# Site Audit Report

Residential Parcel 1

Client: Hydro Aluminium Kurri Kurri Pty Ltd

14-Sep-2020

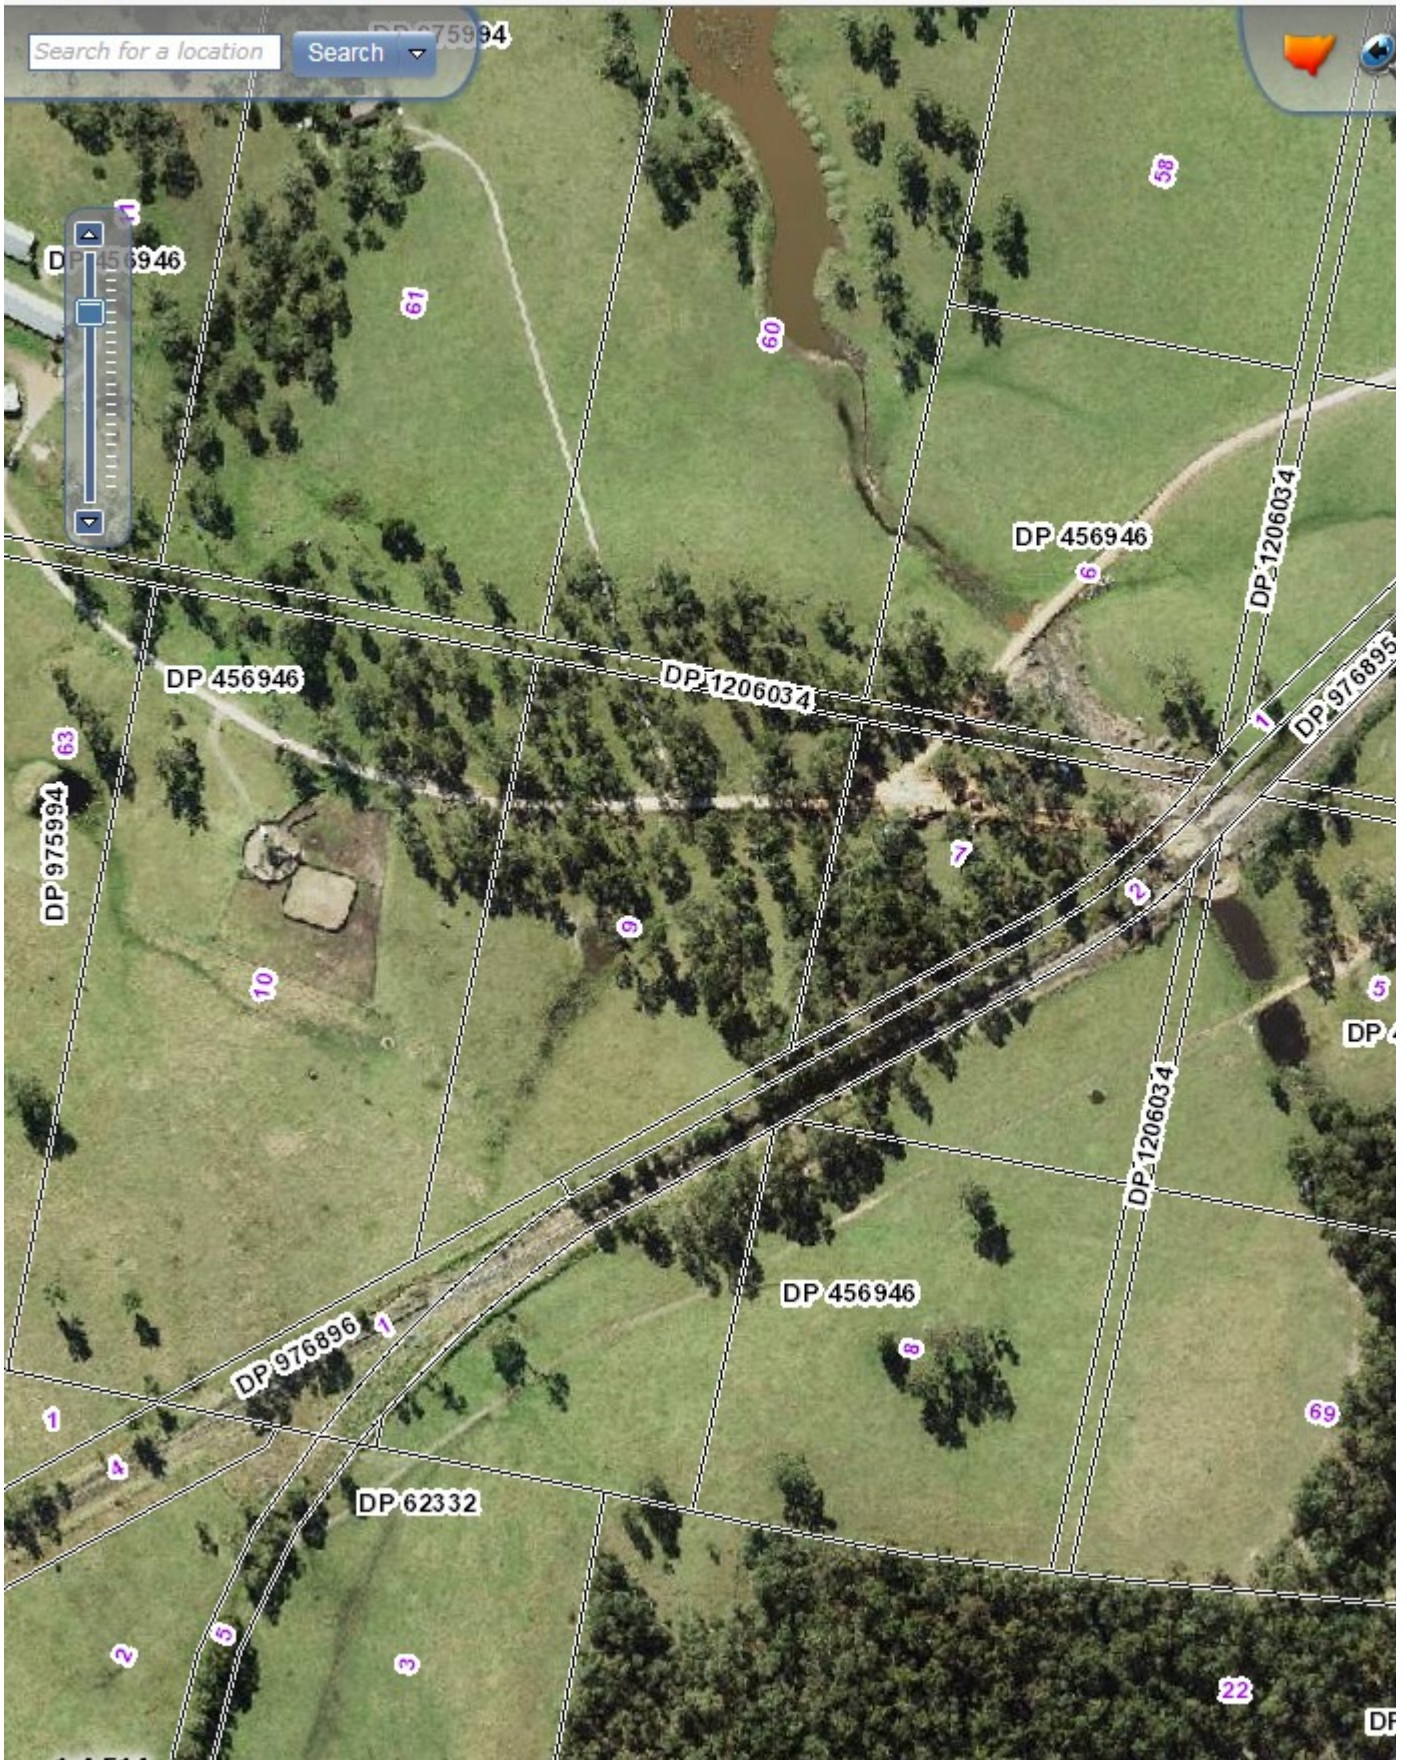
Hydro did acquire former Crown land and therefore, we do need to add a part lot to Res Parcel 1: Part Lot 1 in DP 1206034 as shown below.

As discussed, this narrow portion of land is not fenced off and was assessed as part of the environmental investigations undertaken.

**Figure 2: New Boundaries of Residential Parcel 1 and Parcel 2**

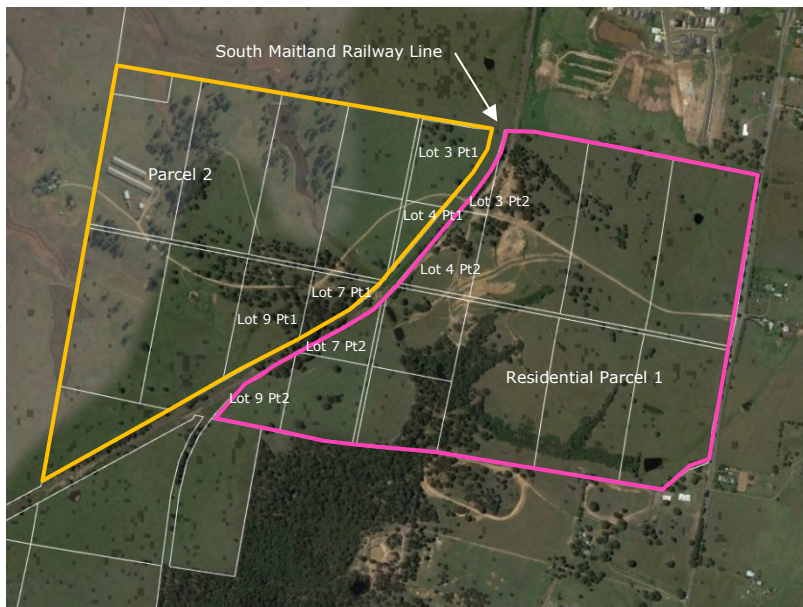
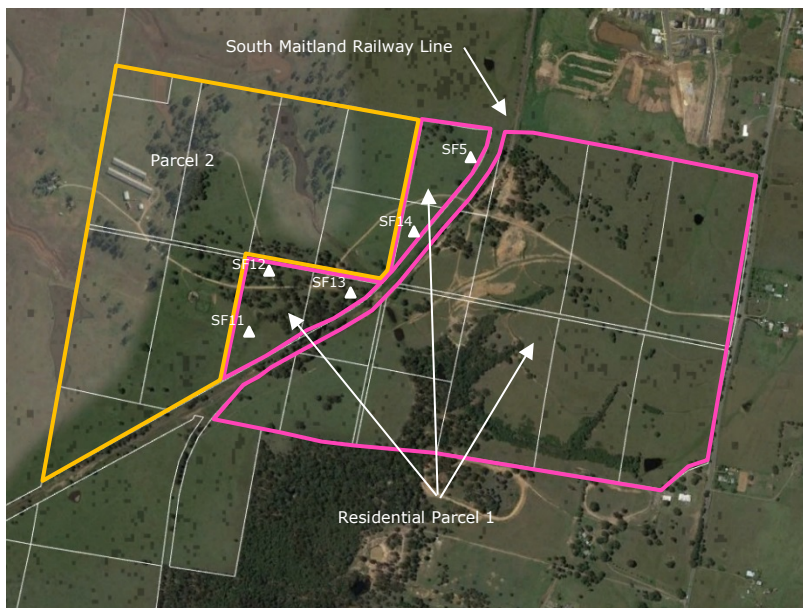
The four affected lots are Lot 3, Lot 4, Lot 7 and Lot 9 in DP 456946. The former boundaries of Residential Parcel 1 and the adjacent Parcel 2 are shown in **Figure 1**, with the new boundaries shown in **Figure 2**.

The maximum soluble fluoride concentration was 1 mg/kg, well below the site criteria. The location of fluoride soil samples are shown on **Figure 2**. A summary of the laboratory results are in **Table 1** and the laboratory report ES1324135 is attached.
